Scotch-Weld™
Structural Adhesive

Duo-Pak Delivery System Updates

Q1 2018

New isolated outlet to prevent cross-contamination

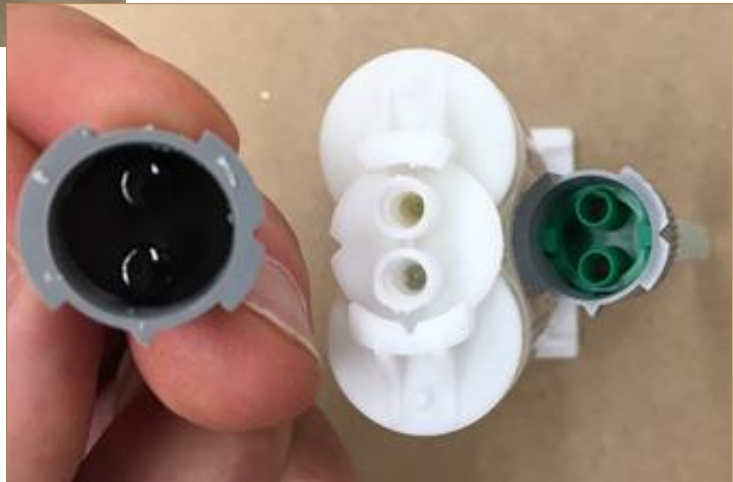
The current cap can be installed backwards on a partially dispensed cartridge, permanently sealing the cartridge shut. This renders the remaining adhesive useless.

The new cap is keyed and cannot be installed backwards, so partially consumed cartridges can be saved and used later.

Cartridge volume changes

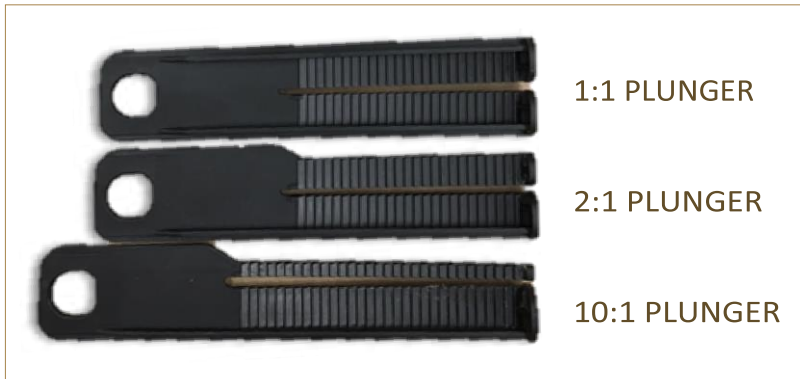
The contained volume of the 3M Duo-Pack cartridges has changed.

In addition, the new 1:1 System has one cartridge style, instead of three per the old packaging.
